Our Ref: CE18119 **CGRC Water Main – Response to RFI dated 23 January 2024**
Contact: Lloyd Moloney/Derek Arrowsmith

RE: Request for Information to aid the design process to extend and expand the provision of the Gundagai potable water supply to the DOTT development proposal at Lot 529B DP230601 and Lot 2 DP160191 – 37 Annie Pyers Drive, Gundagai

Diurnal Peak Day Demand Curves comparing development site as residential with development site as commercial.

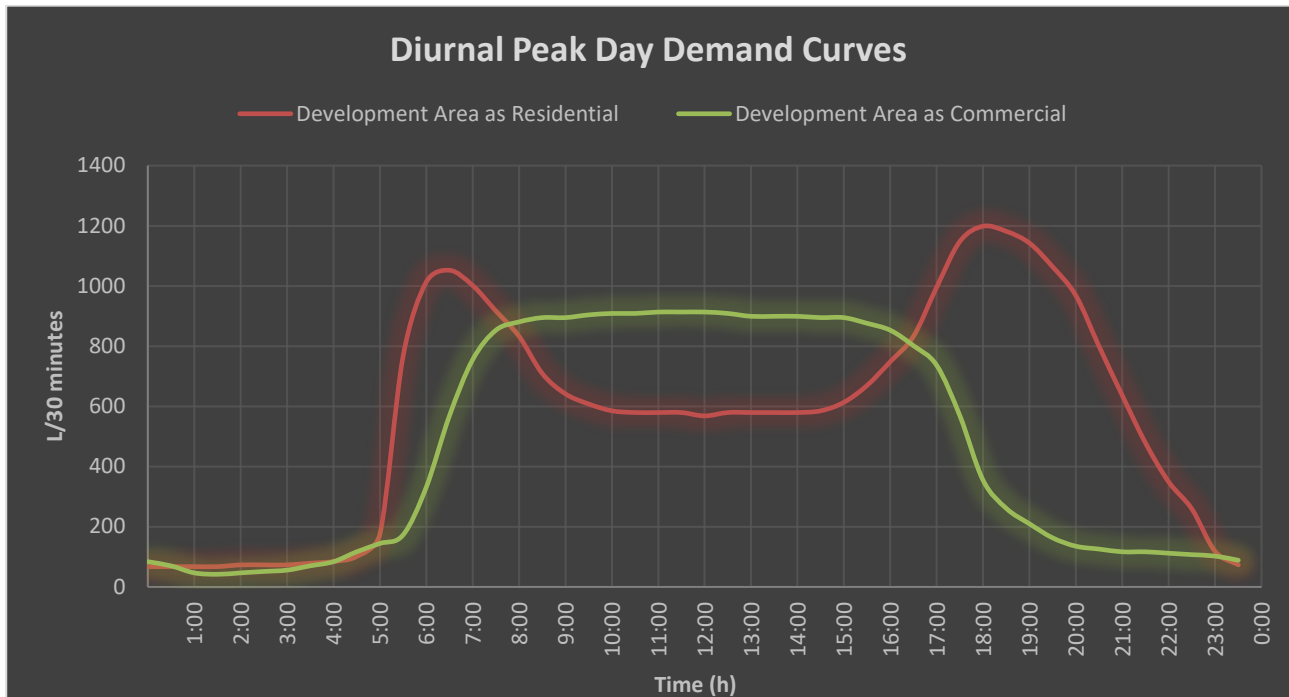
To support your proposed development CGRC have requested the following information to be provided in regard to water supply to DOTT for each stage (both individual and cumulative):

- a) Maximum flow rate required at any given time in litres per second.
- b) Maximum volume of water required over a 3, 6, 12, and 24 hour timeframe and a seven day timeframe. This information must include peak business time (Christmas Holiday Period). Such information is to be provided as litres per hour over each timeframe.
- c) Water demand and pressure requirements for Fire (Safety) Services. This information will need to be undertaken by an accredited Fire Service Engineer.

The results from the altered development site diurnal patterns have been applied to those previously reported Figure 2 in the MSE design report **Attachment 3** adjusted to show either the demand in L/30 min or cumulative volume as opposed to the usage factors. The Diurnal and cumulative supply curves are included in **Attachment 2**.

The peak hour flow rate for the DOTT Development Area as a commercial development is 2.025L/s.
